SUBJECT: *Secret* Forwards "Design Reverification Program," Vols 1 & 2, final assessment rept. Results of program will be presented to NRC in late Oct 1983.

Subject: WNP-2 Design Reverification Program

# WASHINGTON NUCLEAR PLANT 2 DESIGN REVERIFICATION PROGRAM

SAR CHANGE NOTICE

WASHINGTON PUBLIC POWER SUPPLY SYSTEM NUCLEAR PROJECT NO. 2	BREAK LOCATIONS AND RESTRAINTS ANALYZED, PDA VERIFICATION PROGRAM	FIGURE 3.6-35a
--	---	----------------

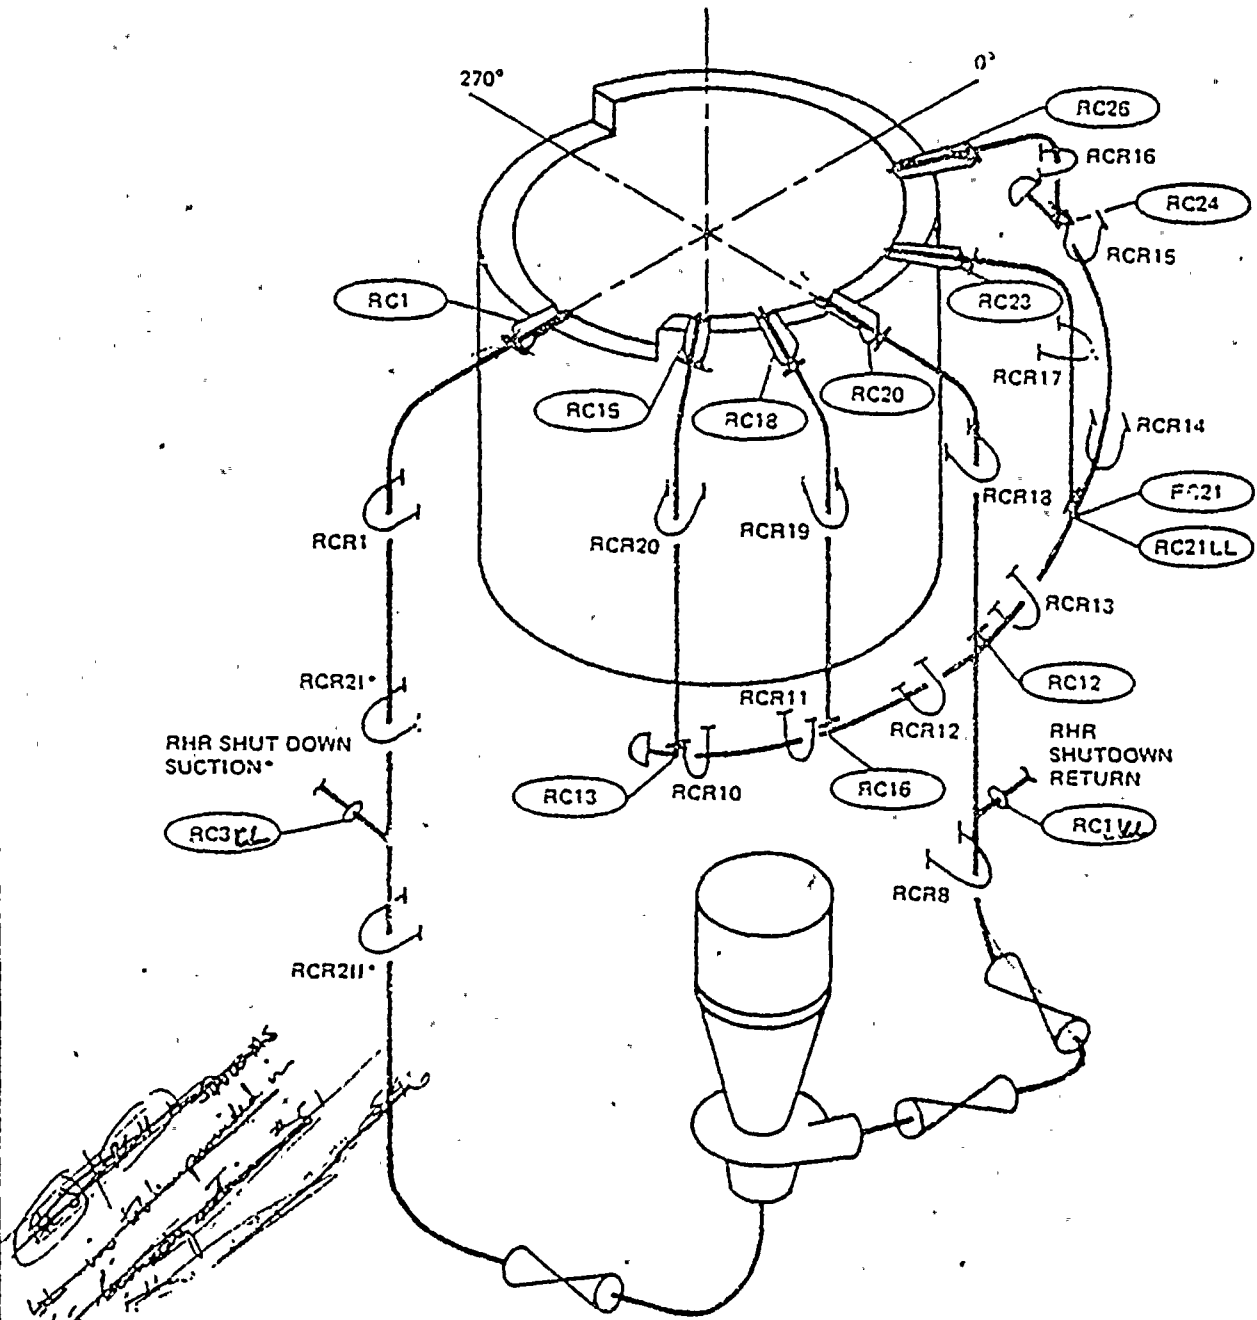
REPLACE  
 following P&ID  
 with

*Handwritten notes:*  
 RC3LL is a longitudinal break in the RHR shutdown suction line.  
 RC3LL is a longitudinal break in the RHR shutdown return line.  
 RC3LL is a longitudinal break in the RHR shutdown suction line.

FIGURE 3.6-18L

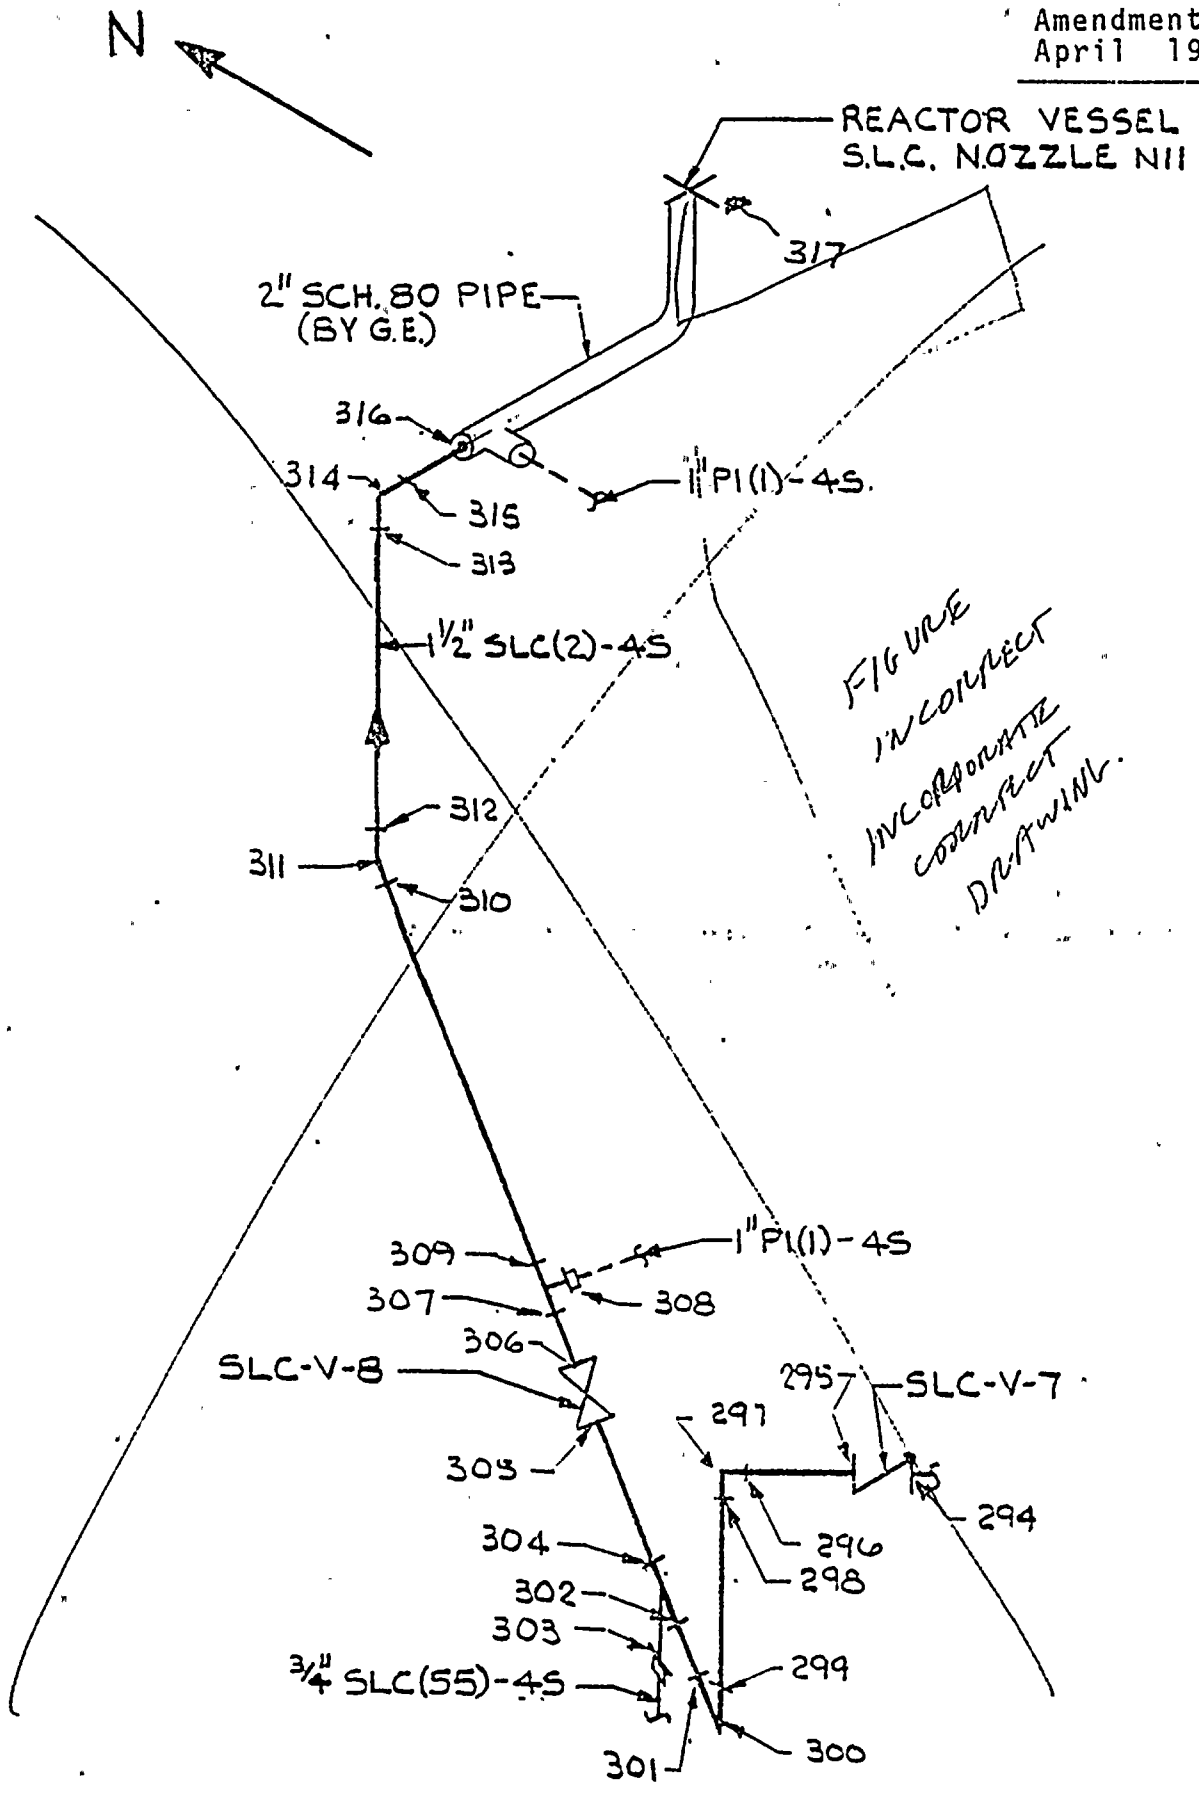
FIGURE  
INCORRECT  
INCORPORATE  
CORRECT  
DRAWING.
